DOCKET NO.: FCI-2701/C7123B
Application No.: 09/886,550
Office Action Dated: January 21, 2004

PATENT
REPLY FILED UNDER EXPEDITED
PROCEDURE PURSUANT TO
37 CFR § 1.116

REMARKS

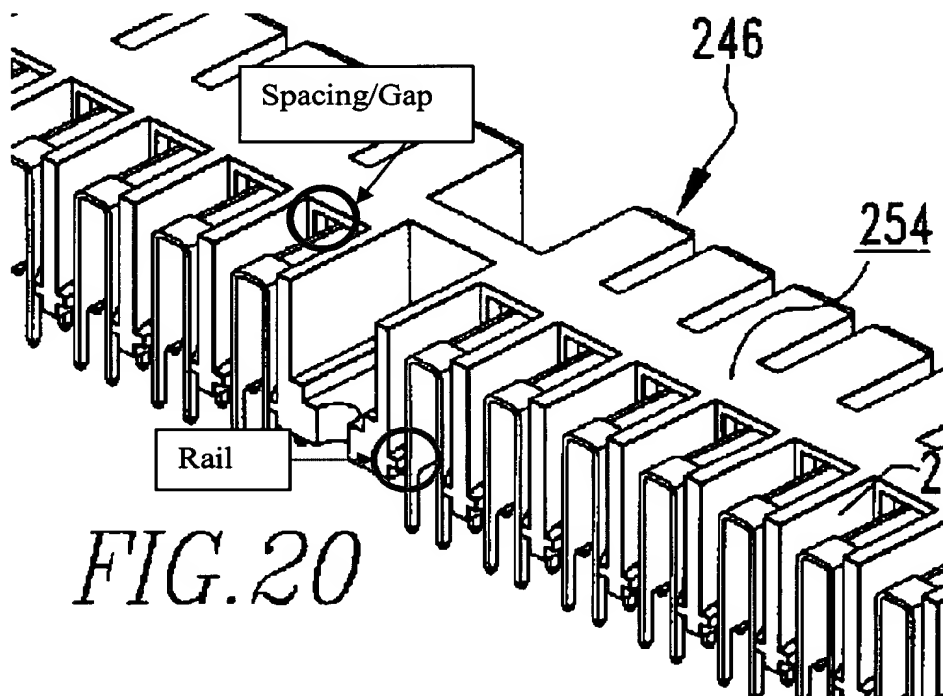
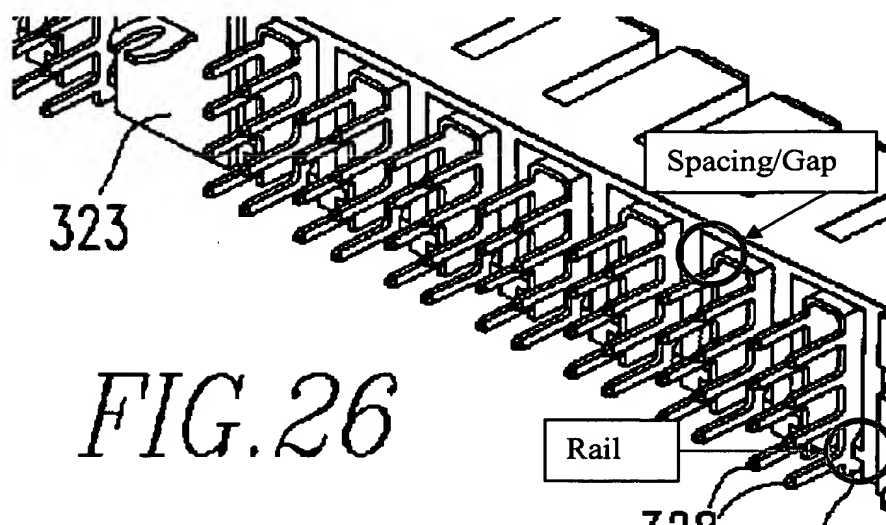
The examiner states that “the features ‘wherein a substantial portion of at least one of the first planar panel and the second planar panel is spaced from an adjacent housing wall such that heat dissipation can also occur from an exterior contact surface’ [is] confusing and unclear.” Applicants respectfully disagree. Several of the connector embodiments shown in the figures clearly show at least one of the planar contact panels being spaced apart from adjacent housing structure. By way of example, portions of Figures 20 and 26 are reproduced below to illustrate the spacing or gap (highlighted with a red circle) between a contact panel and an adjacent cavity (housing) sidewall.

And as noted above, the drawings in patent applications, particularly in electro-mechanical cases, provide “written description” support to comply with the first paragraph of 35 U.S.C. § 112. As can be seen in the above figures, the contact receiving cavities can optionally employ “rails” (highlighted with a blue circle) extending inwardly from their side walls. Such rails maintain spacing between the contact panels and the adjacent housing structure. Furthermore, some of the preferred contact embodiments employ a laterally extending tang, such that an associated contact wall/panel will necessarily be spaced from an adjacent housing/cavity wall. For example, plug contact 208 (shown in Figure 17 and reproduced below) employs a tang 222 which is said to “center[] the contact within cavities 212 in housing 222” (page 9, lines 4-6). The Federal Circuit in *All Dental Prodx*, stated that “the failure of the specification to specifically mention a limitation that later appears in the claims is not a fatal one when one skilled in the art would recognize [it] upon reading the specification.” 309 F.3d at 779.
